Management Assessment of Alternative Methods for Exploratory
Shaft Construction/Testing Sequences and
Additional Exploratory Drifting

September 1989

Prepared by the U.S. Department of Energy in Response to
Suggestions from the Structural Geology and Geoengineering
Panel of the Nuclear Waste Technical Review Board

FIGURE 1

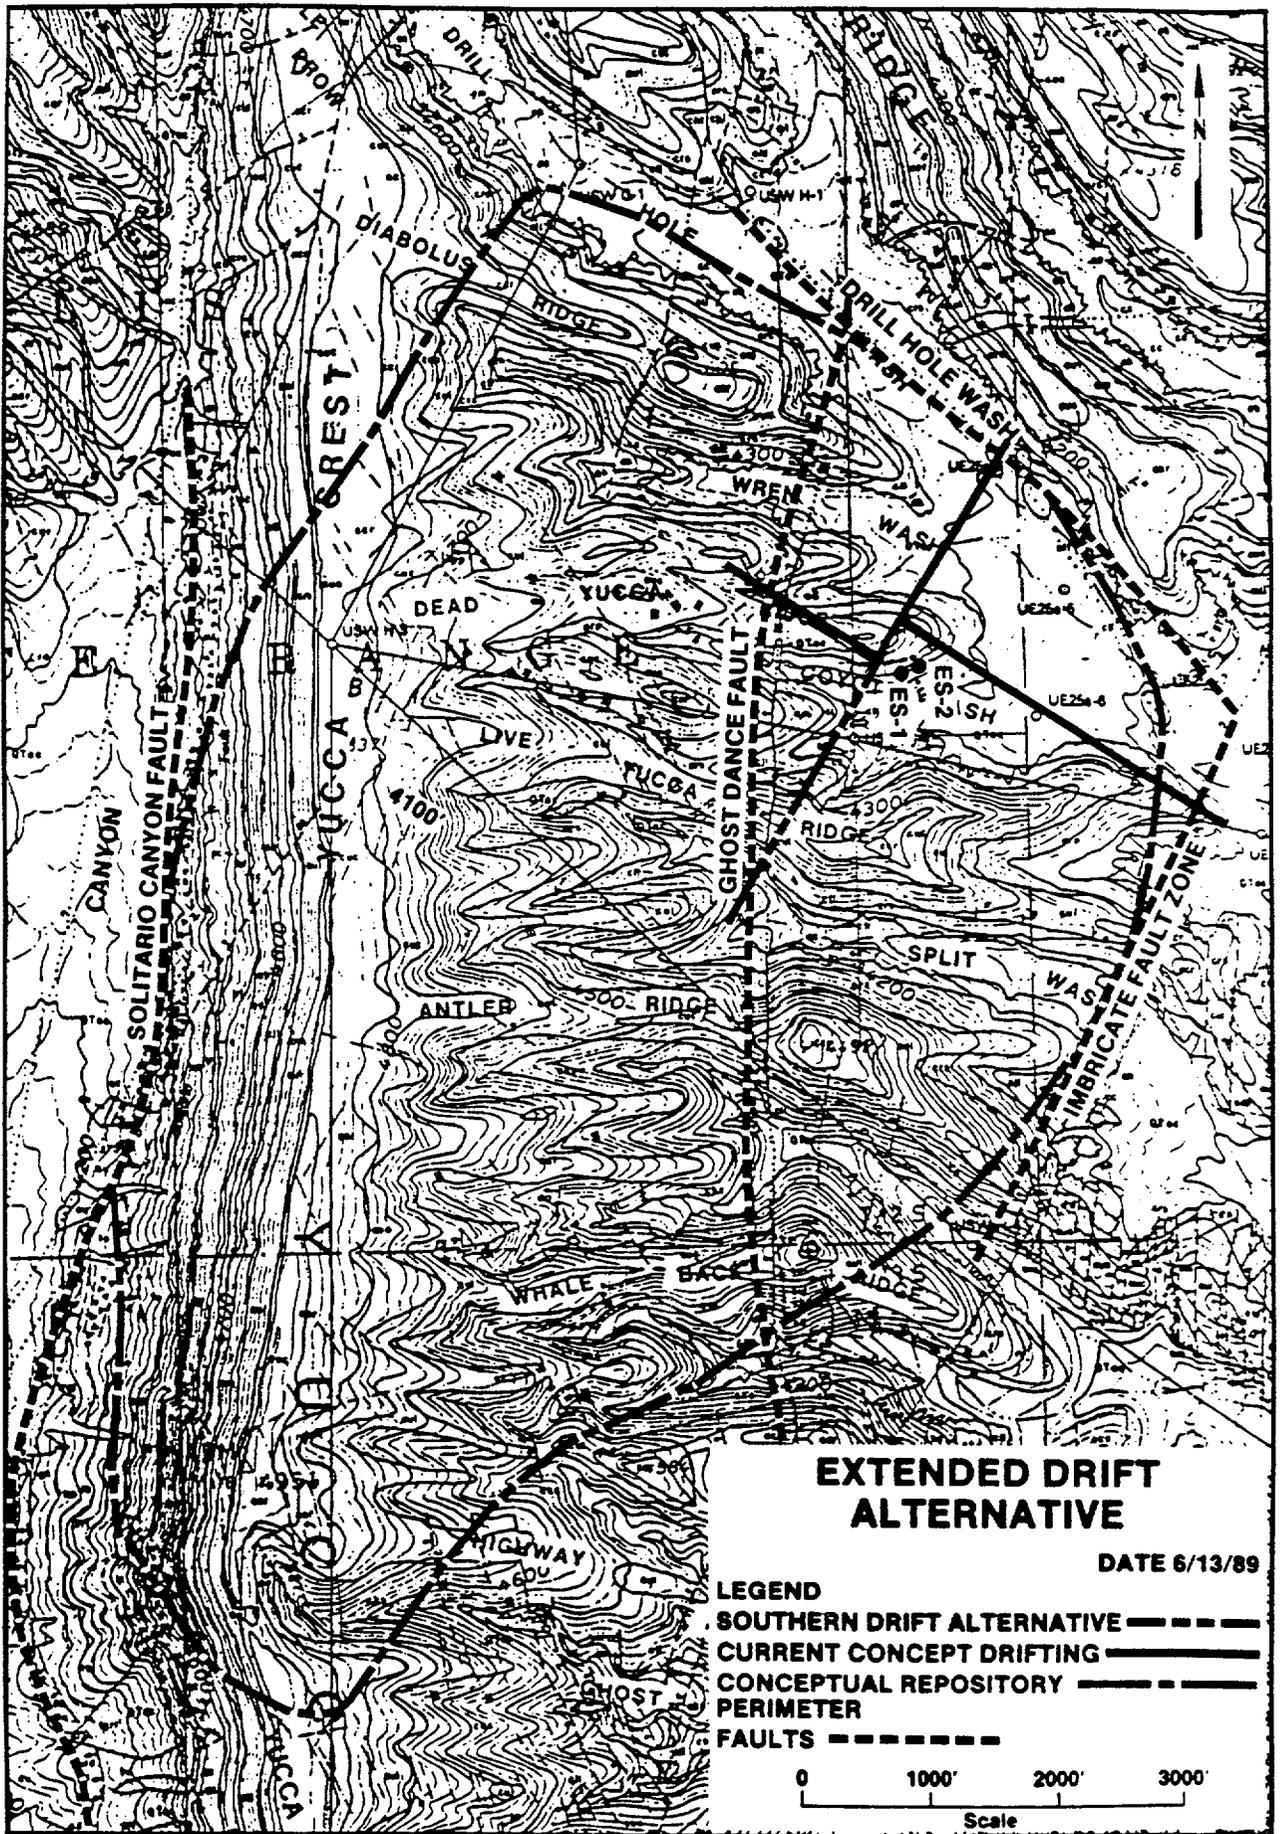
Consider expanding the currently planned exploratory drifting to the Ghost Dance Fault to include an exploratory drift to the south to intersect the fault at additional locations where the offset appears to be significant.

The principal purpose for drifting to the Ghost Dance fault (Figure 1) is to obtain hydrologic and structural data for performance assessment and repository design. The hydrologic characteristics of this major fault zone which transects the proposed repository block are particularly important to the modeling of site ground-water flow paths and travel times. Ground-water flux through the host rock is expected to be negligible and fault or fracture zones could represent preferential pathways for such flow. Although the currently planned intersection with the Ghost Dance fault is believed to offer a reasonable opportunity for obtaining representative hydrologic data for the fault zone, there is some indication on the surface that the Ghost Dance fault may be a hinged fault with increased displacement to the south. The magnitude of this offset, important for repository design, and potentially associated hydrologic variability have yet to be established.

Since displacement apparently increases to the south, a southern intersection (e.g., approximately midway between the currently planned

intersection and boreholes UZ-7 and UZ-8) may be more representative of the hydrologic and structural conditions at the MTL, and would provide added confidence to the characterization of this structure.

- Several lines of closely spaced surface-based boreholes across the Ghost Dance fault, which could include inclined boreholes, and detailed surface mapping along the fault, should be considered to obtain additional information on fault characteristics and stratigraphic offset.
- The addition of an exploratory drift to the south for a second intersect with the Ghost Dance fault offers sufficient additional benefits relative to costs to warrant its inclusion in the exploratory drifting plans.
- If only one exploratory drift is driven to the Ghost Dance fault, it should be an exploratory drift to the south rather than the currently planned exploratory drift to the northwest.

FIGURE 6-1

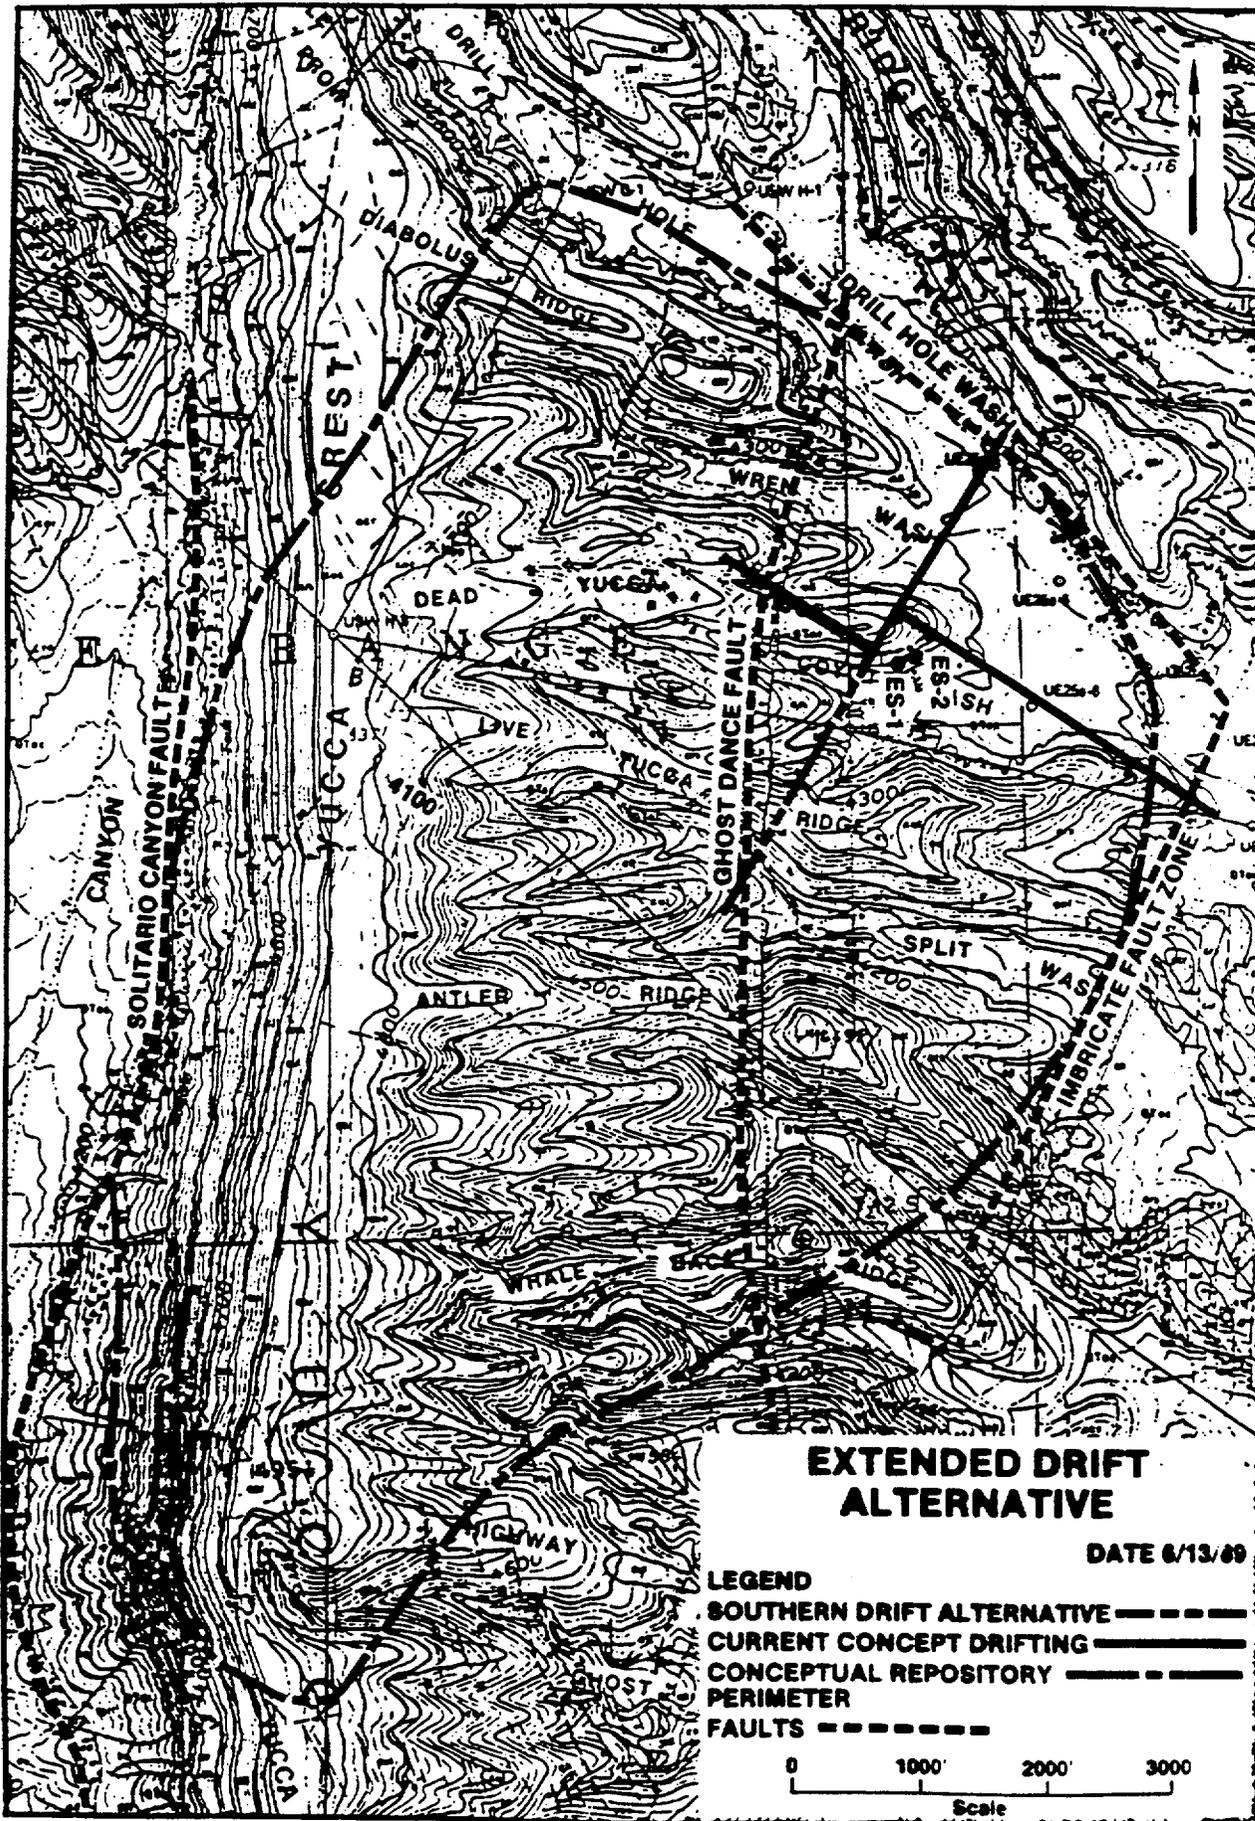
- It appears that an extended exploratory drift can be excavated without a significant adverse impact to the program schedule;
- The extended exploratory drift to the Ghost Dance fault (Figure 6-1) will reduce uncertainty regarding structural and hydrologic characteristics along the southern portion of the fault;

FIGURE 8-1

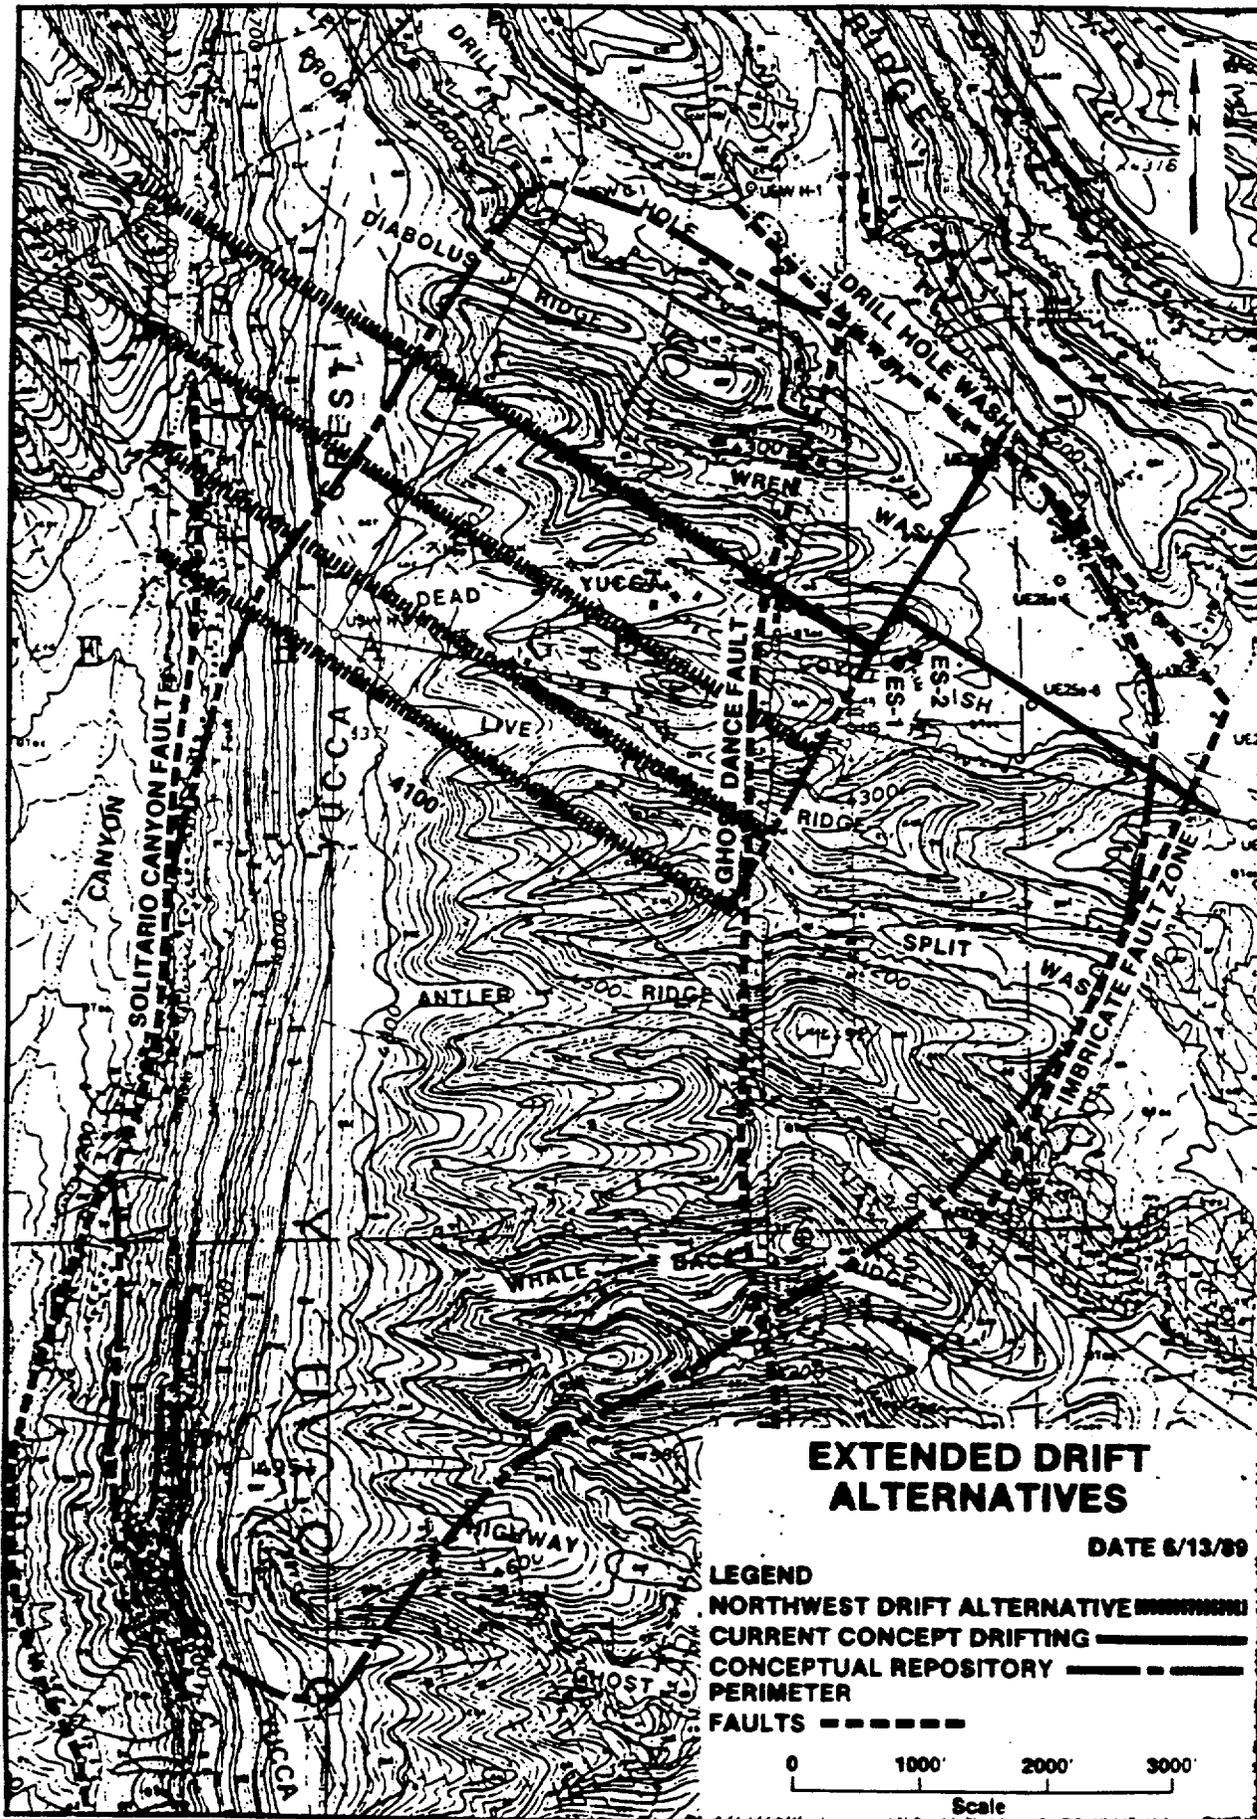
- Depending on the location of the feature(s) of concern, an additional exploratory drift approximately 4,100 feet long could be located coincident with one of several proposed panel access drifts (Fig. 8-1) in the conceptual underground repository layout. The location and grade of an appropriate panel access drift is less likely to change after new site data have been incorporated into repository design.

This alternative to the planned program would consist of an additional exploratory drift approximately 4100 feet long, driven northwest from the proposed southern extension of the conceptual repository main (or from the planned drift to the Ghost Dance fault). In order to be compatible with the conceptual design of the repository, the drift would be located to be coincident with a proposed repository panel access drift in terms of orientation and grade (Fig. 8-1).
